CITY OF ALBUQUERQUE

**Re: St. Andrew Presbyterian Church Sidewalk Culvert Plan
Engineer's Stamp dated 2-4-09 (G18/D009)**

Re: St. Andrew Church Grading and Drainage Plan
Engineer's Stamp dated 7-28-03 (G18/D9)

**RE: St. Andrew Presbyterian Church
Grading and Drainage Plan (G-18/D9)
Engineer's Stamp Dated June 6, 2003**

**RE: St. Andrew Presbyterian Church
Grading and Drainage Plan (G-18/D9)
Engineer's Stamp Dated June 6, 2003**

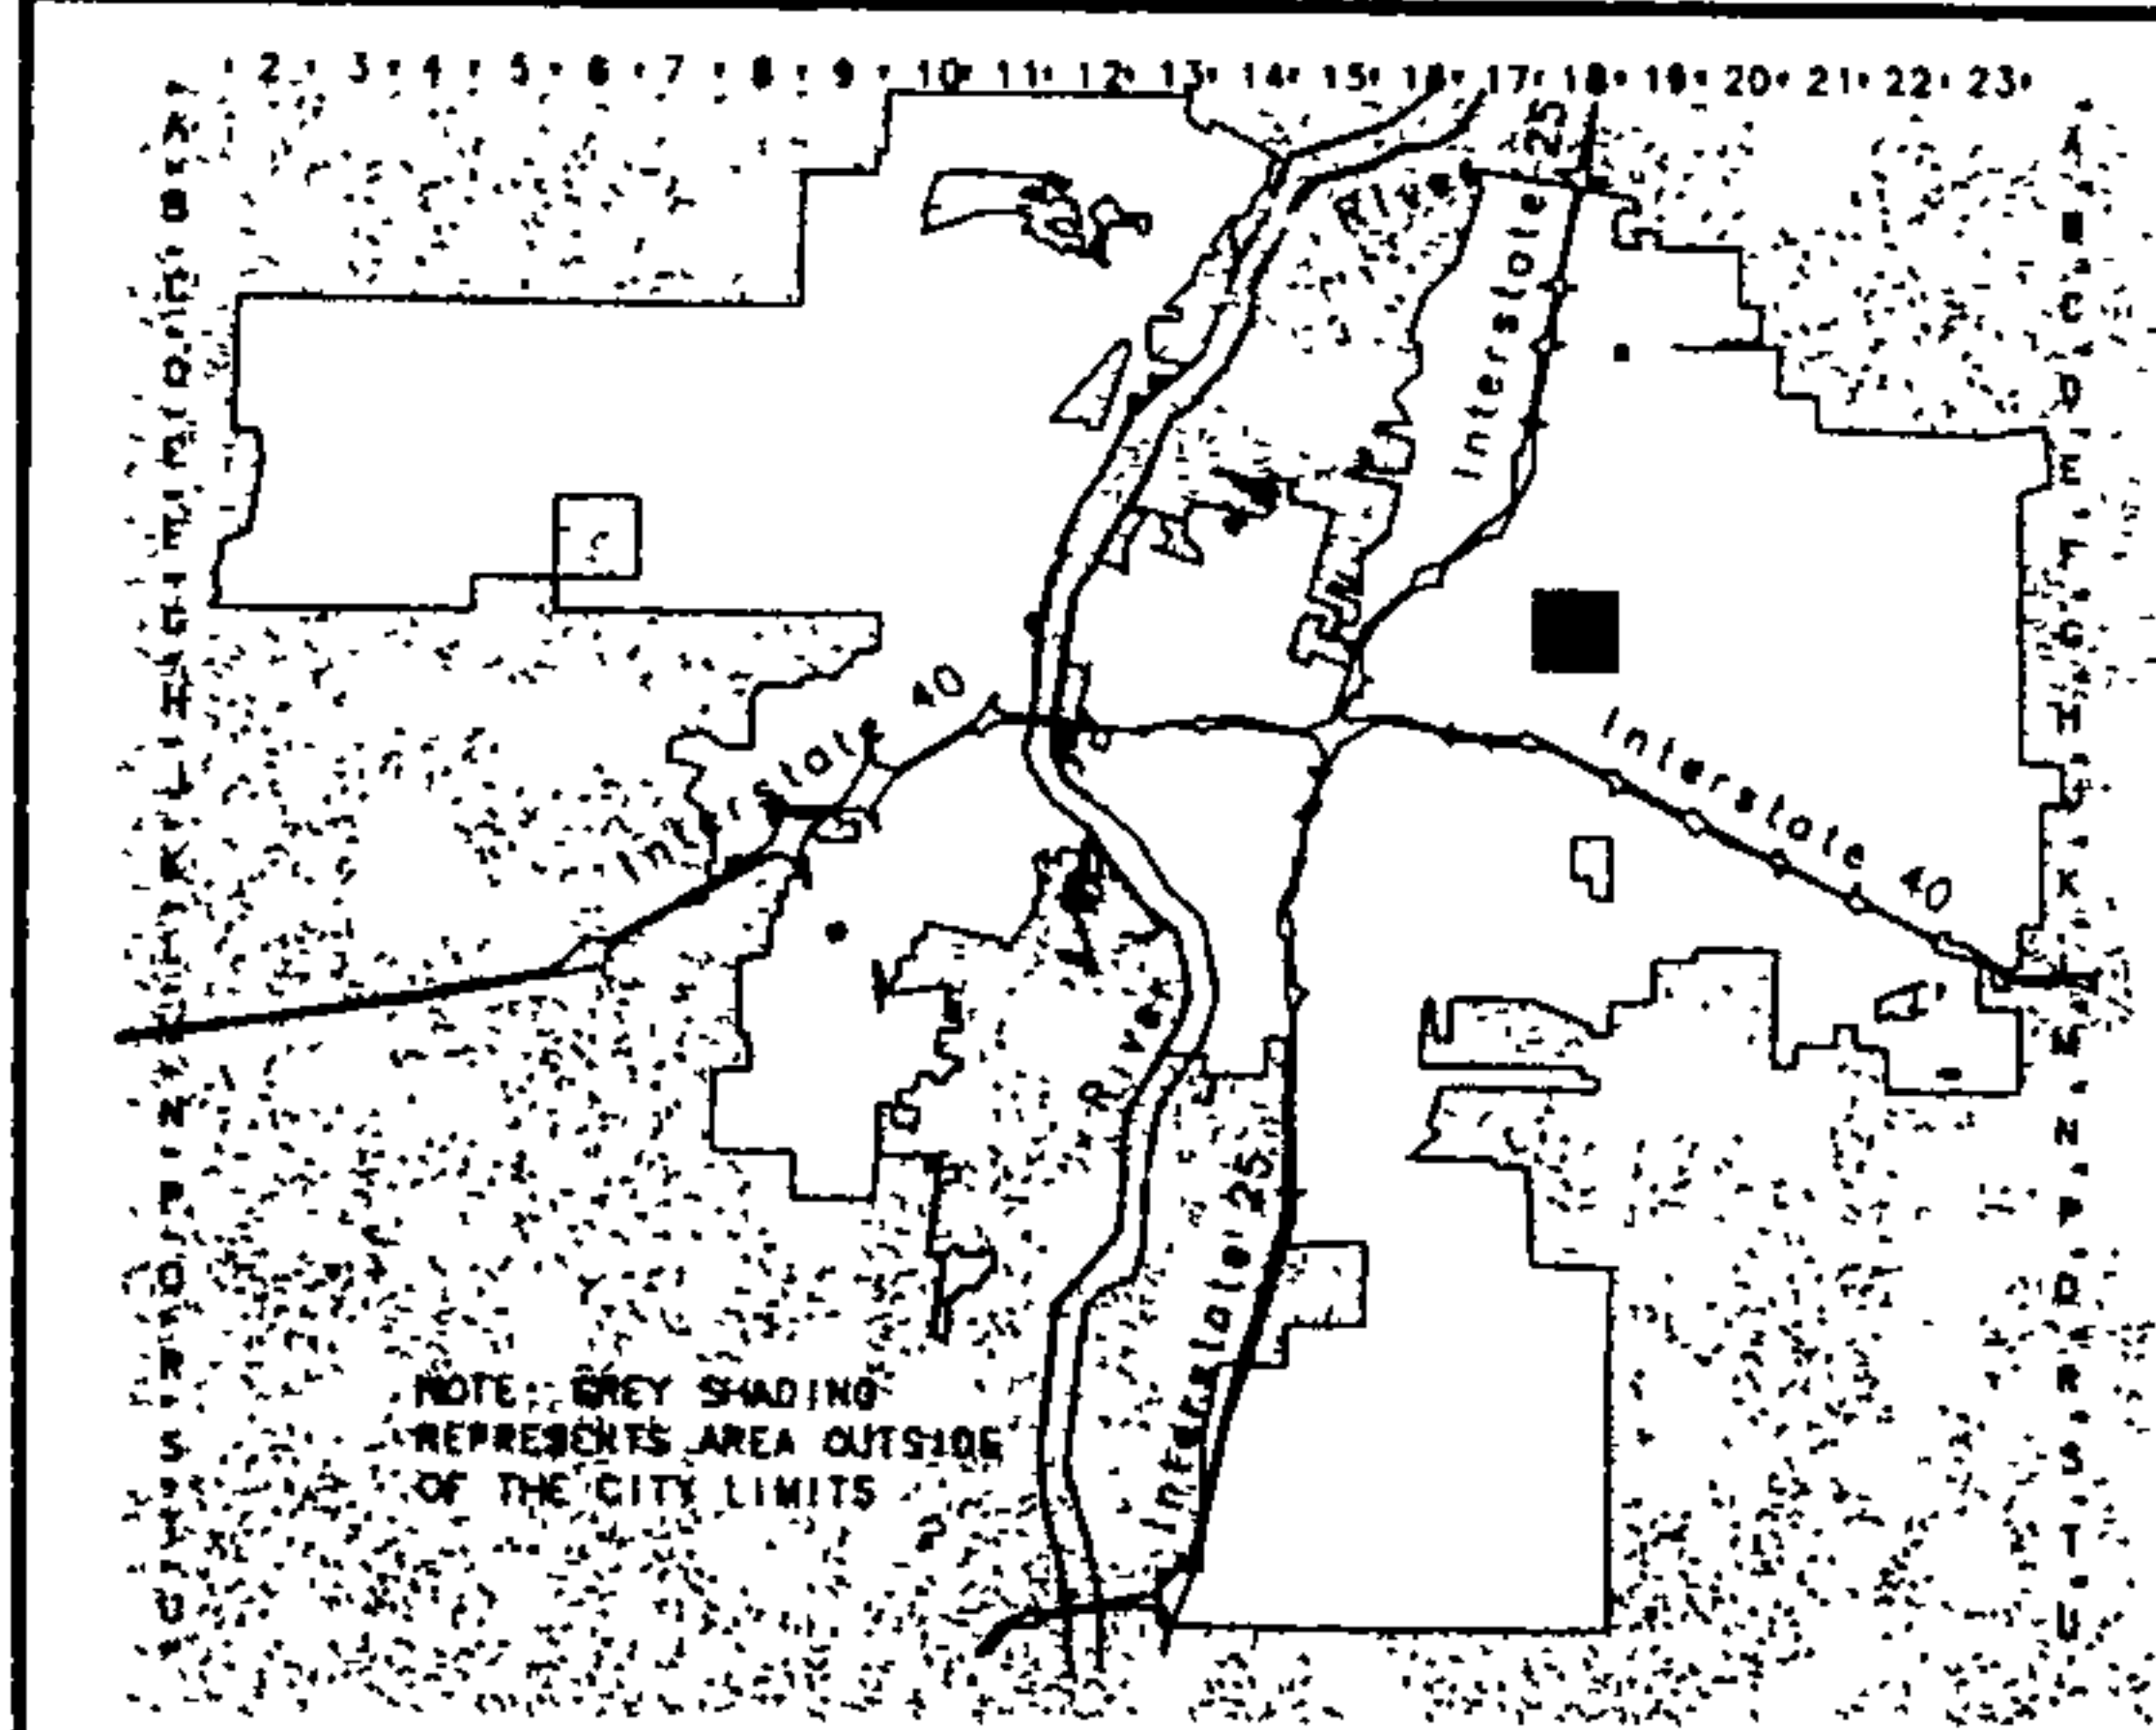
*mark up
given to
Harold*

- Runoff needs to be directed through a sidewalk culvert into Ponderosa Av. Please submit two copies of the drainage and grading plan for SO#19.
- Please explain your statement for the "Existing Peak Discharge."
- Are there any offsite flows? If so, please quantify.
- Please add a legend to indicate hatching and abbreviations.
- Please give more details on runoff of north parking lot at the hand placed stone location.
